## **Central Hillside Community Center**

Accessibility Review

**Photo 1:** View of existing upper lot accessible parking space. There is currently a slope of 9% in the parking space.

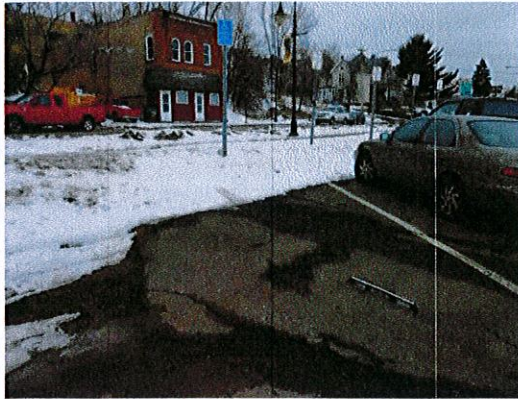
05N1	16532	Relocate accessible parking to a location where the slope / cross slope of the parking area is no greater than 1:48 (2%) in any direction. ICC / ANSI 502.5 <i>The slope is currently 9% within the accessible parking space. Relocating to the opposite side of the parking lot would reduce the slope to 4.3% (still greater than the maximum 2% allowed) and would align the aisle with the new curb cut and shallower route into the building. Photo 1.</i>	1	\$250	\$250	2			
				<i>Location Subtotal:</i>					\$400
				<b>Priority # 2 Total</b>					<b>\$1,650</b>

**Photo 2:** Add handrails to the east route to the upper level entry. (The slope is 6.4%.)

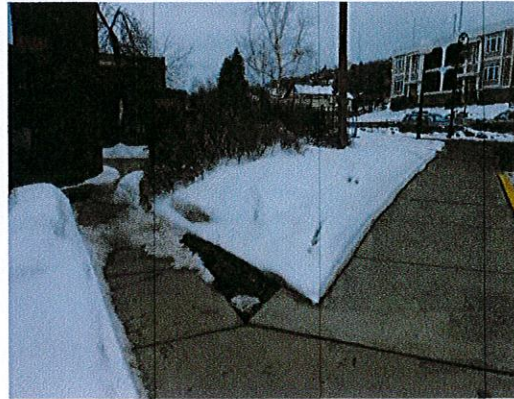
Location	Solution / Comments	Qty	Unit Cost	Total Cost	Priority	Estimated Compl. Date	Person Responsible	Actual Compl. Date	Actual Cost
JQP # / Item #									
<b>Exterior Route- Upper</b>									
09A	16533	Provide fully compliant handrails on both sides of the sloped surface. ANSI 405.8 <i>The east route to the upper level entry currently has a slope of up to 6.4%. Photo 2.</i>	50	\$25	\$1,250	2			
<b>Parking- Rear</b>									
	16491	<i>There is 1 parking space designated as accessible. Currently the dumpster and snow pile are in the access aisle. Photo 4.</i>	1	\$0	\$0	2			
<b>Parking- Upper</b>									
05H	16531	Stripe to provide an accessible parking stall that is 8' wide with an adjacent 8' access aisle. It is preferred that the access aisle be located on the passenger side of the vehicle. MN 1341 502.4.2 <i>There is currently 1 parking space designated as accessible, there is not an aisle. Photo 1.</i>	1	\$150	\$150	2

**Photo 5:** View of mezzanine conference/meeting room. There is not currently an accessible route to this location.

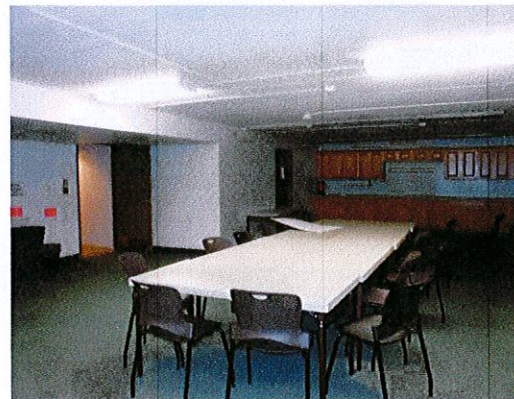
Location	Solution / Comments	Qty	Unit Cost	Total Cost	Priority	Estimated Compl. Date	Person Responsible	Actual Compl. Date	Actual Cost
JQP # / Item #									
<b>Mezzanine- Conference / Meeting</b>									
14D2 16505	Relocate program as necessary to an accessible location to provide program access. MN 1341 1104.4 <i>The mezzanine storage area was converted to a conference/meeting room. There is not currently an accessible route to this level. Photo 5.</i>	1	\$0	\$0	1				
				<b>Priority # 1 Total</b>	<b>\$0</b>

**Photo 6:** Maneuvering clearance is not currently provided into the community room.

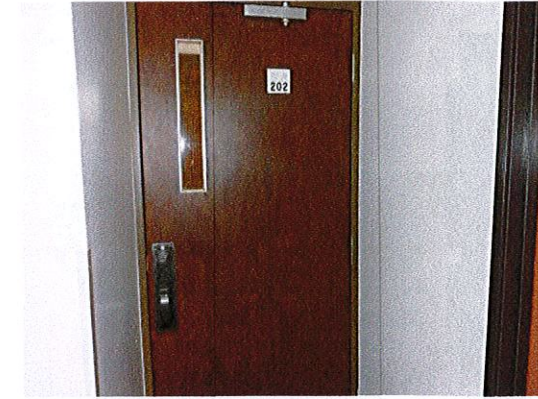
<b>Community Room- Upper Level (202)</b>									
20B 16527	Re-hinge / relocate door to provide needed maneuvering clearance on the latch pull side of the door. ICC / ANSI 404.2.3, Table 404.2.3.1 <i>Currently provides 2". Photo 6.</i>	2	\$400	\$800	4

Central Hillside Community Center  
 Lower Level  
 City of Duluth, MN

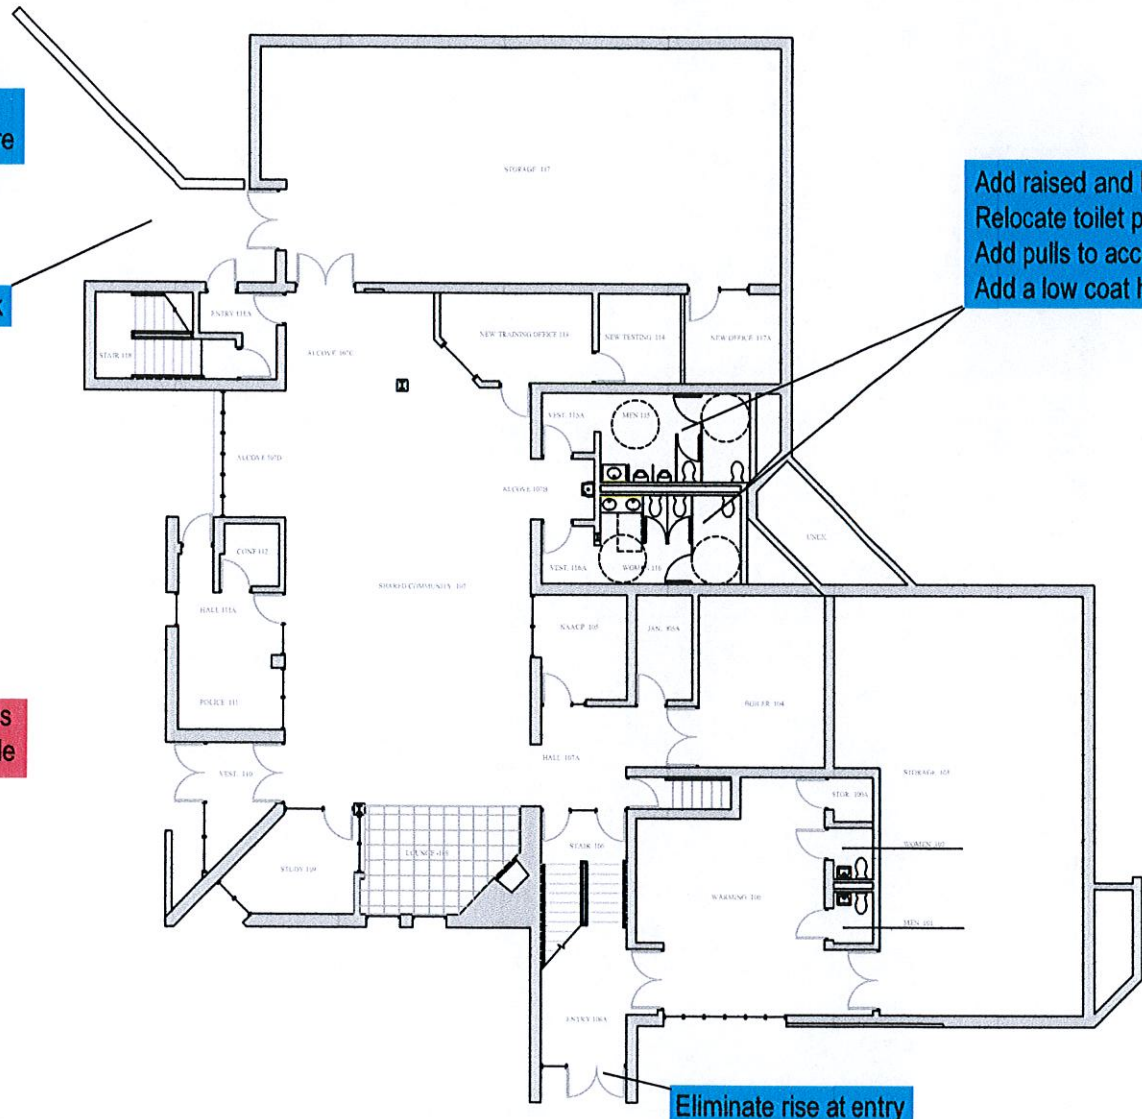
- Provide raised and braille signs
- Replace knob style door hardware

Eliminate rise in sidewalk

- Add raised and braille sign
- Relocate toilet paper dispenser
- Add pulls to accessible stall door
- Add a low coat hook

- Relocate the dumpster so it is not located in the access aisle

Install door lever hardware

Central Hillside Community Center  
Upper Level  
City of Duluth, MN

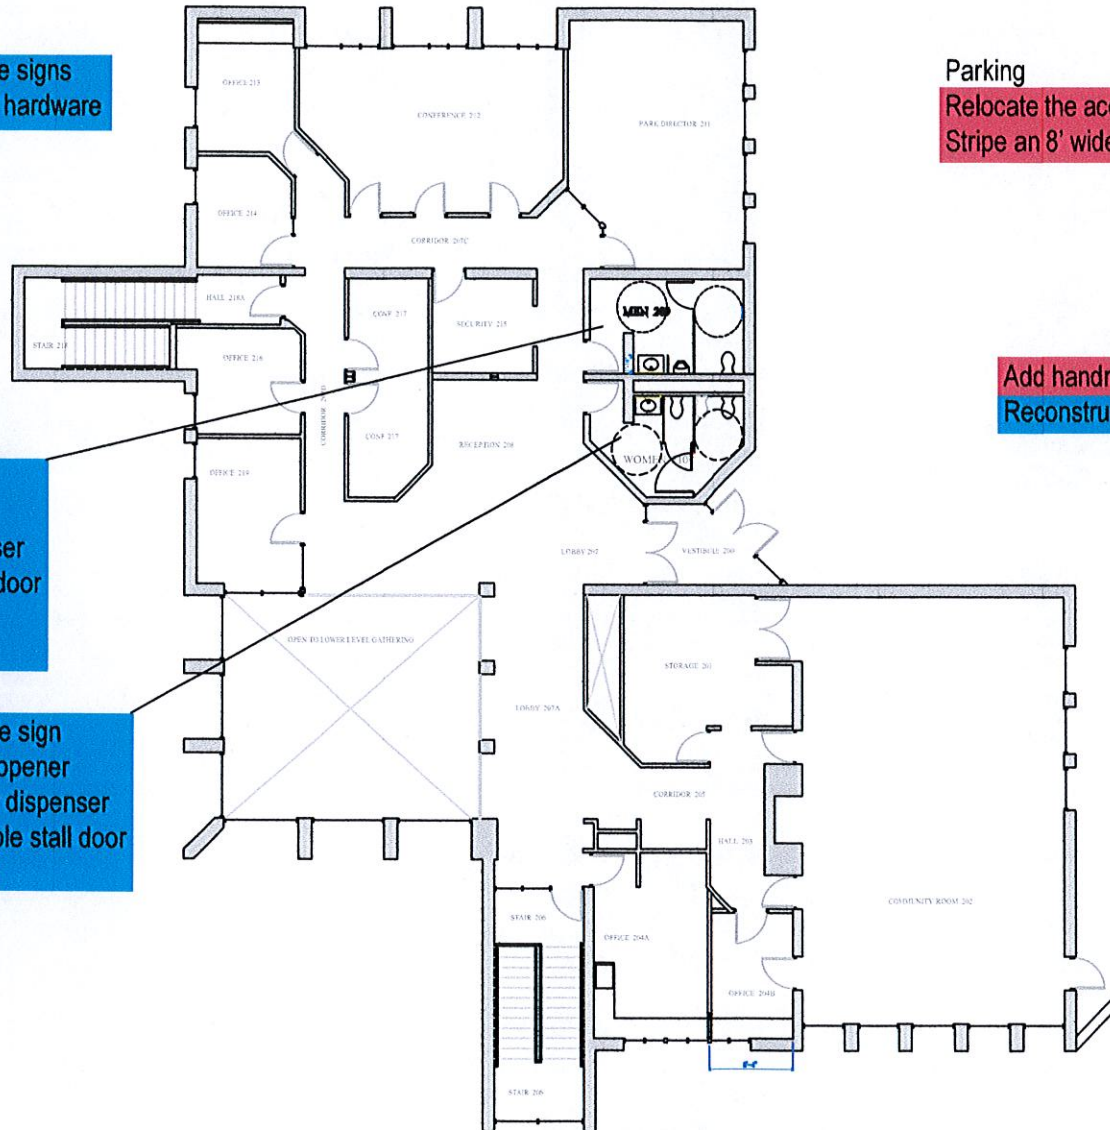
Provide raised and braille signs  
Replace knob style door hardware

Relocate the accessible parking space  
Stripe an 8' wide access aisle

Add raised and braille sign  
Install a power door opener  
Relocate toilet paper dispenser  
Add pulls to accessible stall door  
Add a low coat hook  
Lower 1 urinal

Add raised and braille sign  
Install a power door opener  
Relocate toilet paper dispenser  
Add pulls to accessible stall door  
Add a low coat hook

Add handrails to the east ramp  
Reconstruct the west route to reduce slope

L Install door lever hardware

Central Hillside Community Center  
Mezzanine  
City of Duluth, MN

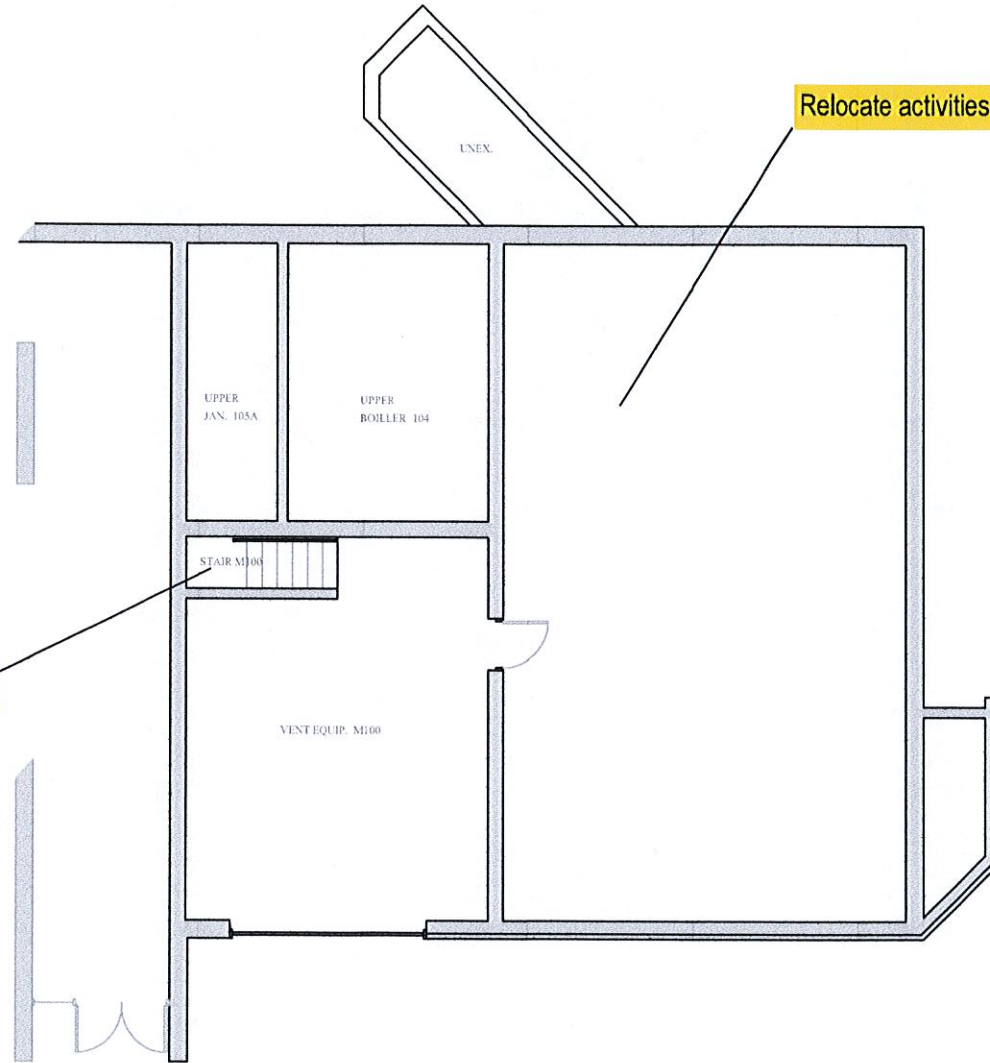
- Provide raised and braille signs
- Replace knob style door hardware

Relocate activities to an accessible location

Create an accessible route between levels
